Subject: Fifth Set of Responses to the Second Round of NRC's Request for Additional Information by the Office of Nuclear Reactor Regulation for Topical Report (TR) WCAP-16747-P, "POLCA-T: System Analysis Code with Three-Dimensional Core Model" (TAC No. MD5258) (Proprietary/Non-Proprietary)

**Fifth Set of Responses to the Second Round of NRC's Request for  
Additional Information by the Office of Nuclear Reactor  
Regulation for Topical Report (TR) WCAP-16747-P,  
"POLCA-T: System Analysis Code with Three-Dimensional Core Model"  
(TAC No. MD5258) (Non-Proprietary)**

**NRC RAI 2-12**

Figure 4.1 Cracked pellet segments and relocation deformation

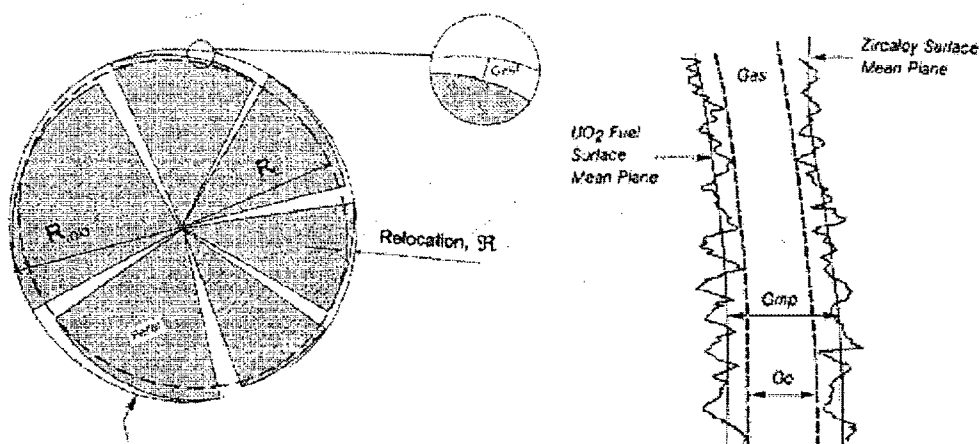
In its review of STAV7.2, the staff lists five conditions in its approving SE. Please refer to WCAP-15836-P-A. Confirm the applicability of these conditions to the current LTR. If it has been determined that a particular condition is not equally applicable to POLCA-T, please provide a detailed rationale justifying the position.

In all STAV versions [ ]<sup>a,c</sup>, except for in STAV7.2 where [ ]<sup>a,c</sup> during the model calibration of thermal gap heat transfer to best fit the measured fuel temperatures. As can be seen in figure 4.1 below, the (partial) contact fraction of relocated cracked pellet fragments and clad shall always be smaller than [ ]<sup>a,c</sup>.

Assume there are N relocated pellet segments that fit the relocated cycle having radius,  $R_{relo}$ . Each of the segments contacts the relocated cycle with peripheral length  $S_i$ . Then the azimuthal “misfitting” will be:

From a theoretical point of view relocation, or cracking of the pellet, can not be fully applied to the gas gap heat transfer calculation in the thermal gas gap. Thermal gas gap is the gas gap that is used in calculating the pellet average surface temperature. This means that [ ]<sup>a,c</sup>.
